**Re: 60-62 Beaconsfield Street and 7-13 Queens Parade, Newport
Section 4.55(2) modification of Development Consent DA2019/1280
Statement of Modifications and Environmental Effects**

This Statement of Modifications and Environmental Effects relates to a proposal to modify Development Consent DA2019/1280 under Section 4.55(2) of the *Environmental Planning and Assessment Act 1979*.

Development Consent DA2019/1280 was issued on 23 April 2020 for “*Demolition works and construction of a multi unit housing development with associated carparking and landscaping*”.

12. Roof over eastern pedestrian entry/exit to garage removed

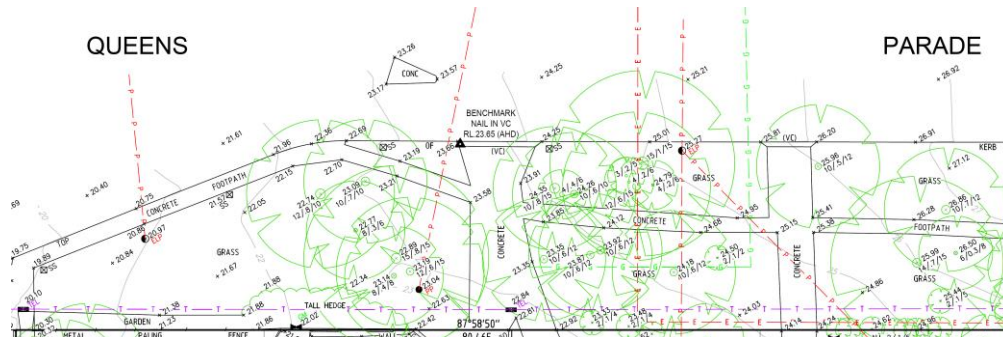
It is proposed to remove the roof over the eastern entry/exit to the garage. The roof is considered to be unnecessary and does not serve any useful purpose. Its deletion will reduce construction costs.
